PRODUCT / PROCESS CHANGE NOTIFICATION

1.1 Company	 STMicroelectronics International N.V
1.2 PCN No.	MDG/24/14484
1.3 Title of PCN	STM32U535x & STM32U545x - product Enhancement
1.4 Product Category	STM32U535x, STM32U545x
1.5 Issue date	2024-04-11

STM32U535xx & STM32U545xx - product enhancement

Example: Marking on package UFQFPN 7X7X0.55 48L

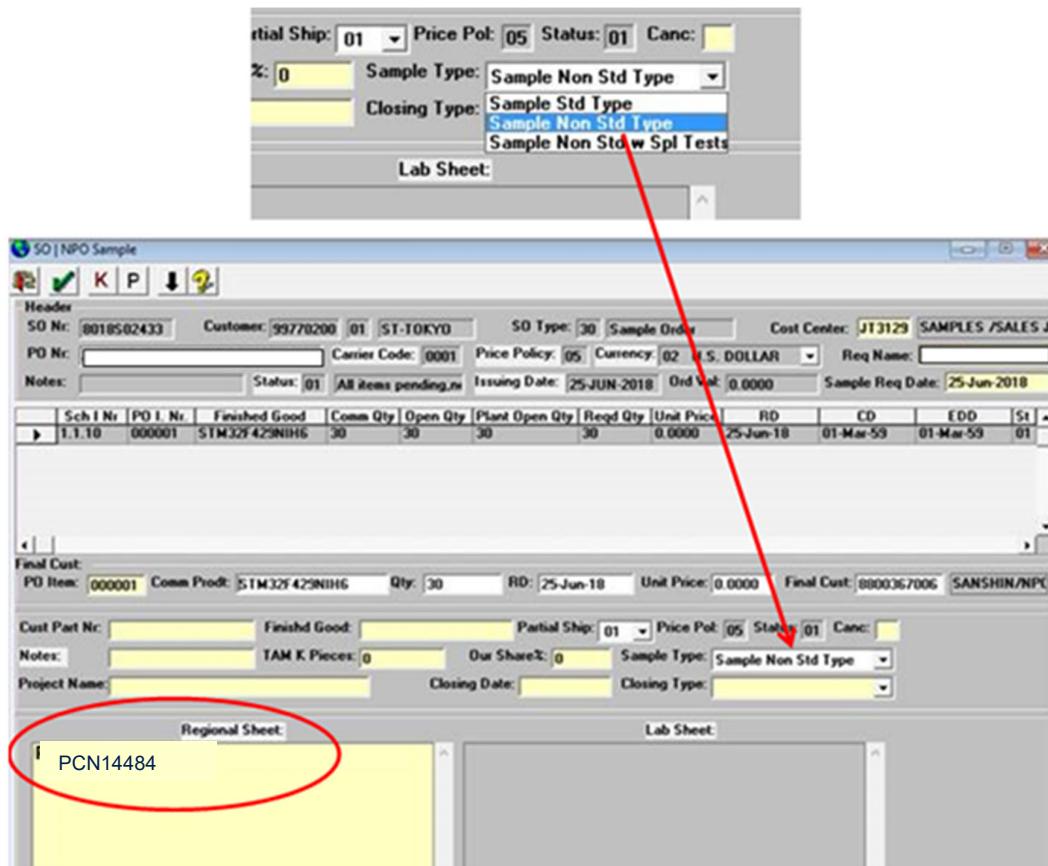
STM32U535xx & STM32U545xx	Current Die 455 CUT 1.1	New Die 455- CUT 1.2
Die revision Marking R	“Z”	“Y”
